HSIP-0006-01(104)/ 109062301000 & HSIP-0006-01(104)/ 109062302000

ADDENDUM

WK. NO.  
REV. 1  
SHEET NO.  
4

SUMMARY OF REVISIONS

**TYPICAL CABLE BARRIER SECTION - I-22 LEFT SIDE**

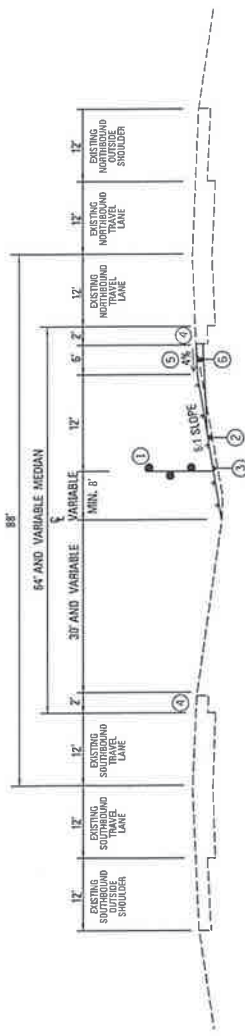
DATE	1st ORDER	ADDENDUM	2nd ORDER	BY	SHEET ID	DESCRIPTION
1/13/2025	X			DED	WK-3,5,8,10,12-13,16,18,22-25,27	REVISED BRIDGE CLEARANCE NOTE
1/13/2025	X			DED	GN-1	ADDED NOTE 30
3/20/25		X		DED	T5-1	REMOVED STA 244+50 TO STA 273+00 AND STA 153+50 TO STA 177+00 FROM I-22 LEFT SIDE

DESOTO COUNTY, SEGMENT 1	MARSHALL COUNTY, SEGMENT 2
STA. 24 + 00.00 - STA. 56 + 50.00	STA. 32 + 50.00 - STA. 67 + 50.00
STA. 87 + 50.00 - STA. 111 + 00.00	STA. 86 + 50.00 - STA. 104 + 50.00
	STA. 112 + 00.00 - STA. 167 + 00.00
	STA. 197 + 50.00 - STA. 239 + 00.00
	STA. 273 + 00.00 - STA. 292 + 50.00
	STA. 412 + 00.00 - STA. 442 + 36.96
